**AMENDED SUBDIVISION PLAN**  
DEACON HAYES COMMONS  
527 WALNUT HILL ROAD - NORTH YARMOUTH MAINE  
OWNER OF RECORD  
**527 LLC**  
865 OAK HILL ROAD - NORTH YARMOUTH, ME

**SHEET SUB-1**

Subject: Approval, Deacon Hayes Commons Engineered SSWW system

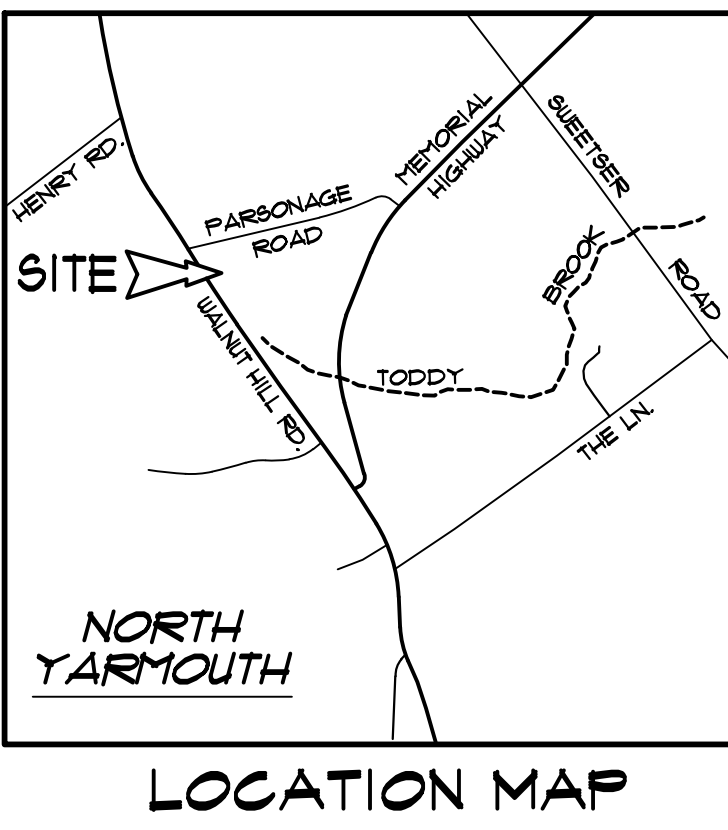
| 4    | 11-25-2022 | ADD COMMON OPEN SPACE & RECREATION LAND |
| 3    | 9-26-2022  | ADD CONDITIONS OF APPROVAL              |
| 2    | 8-27-2022  | RELOCATE WALNUT HILL ROAD SIDEWALK      |
| 1    | 1-16-2022  | ADD STOCKADE FENCE                      |
